**Southern
Water**

Your ref
M/53/19/PL

Proposal: Demolition & erection of 1 No. dwelling.

Site: M/53/19/PL:- 7 Alleyne Way, Elmer, Middleton-On-Sea, PO22 6JZ.

Due to surface water inundation issues in the Lidsey Catchment "The applicant is advised to adopt, where appropriate, the measures in the table "Practical measures to reduce the potential impacts of development".

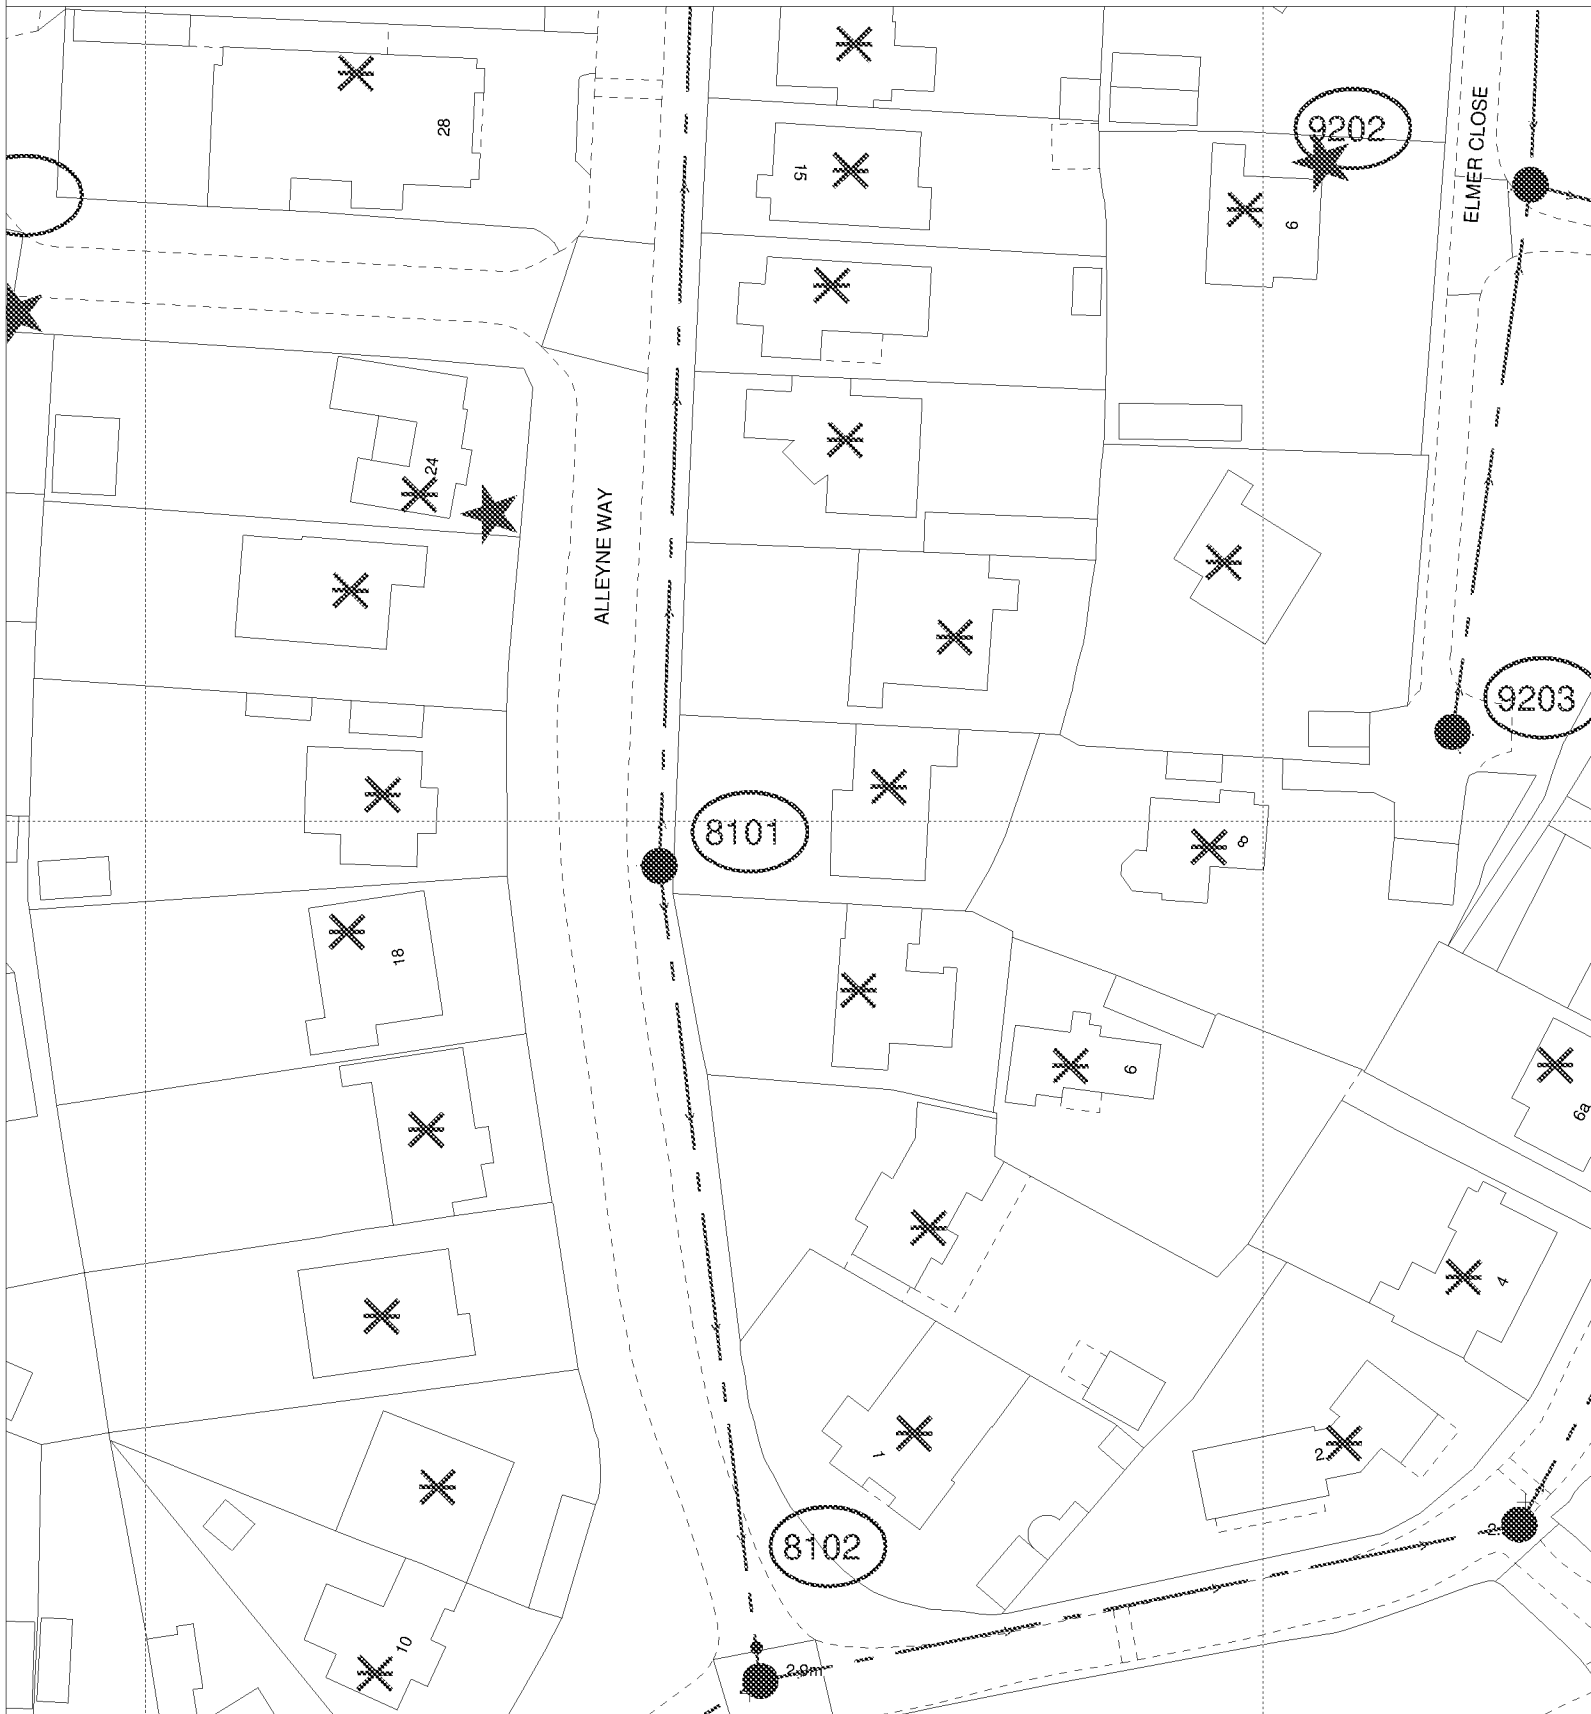
Developer should look to protect the public sewerage system from inundation and infiltration, which contribute to flooding in unfavourable conditions.
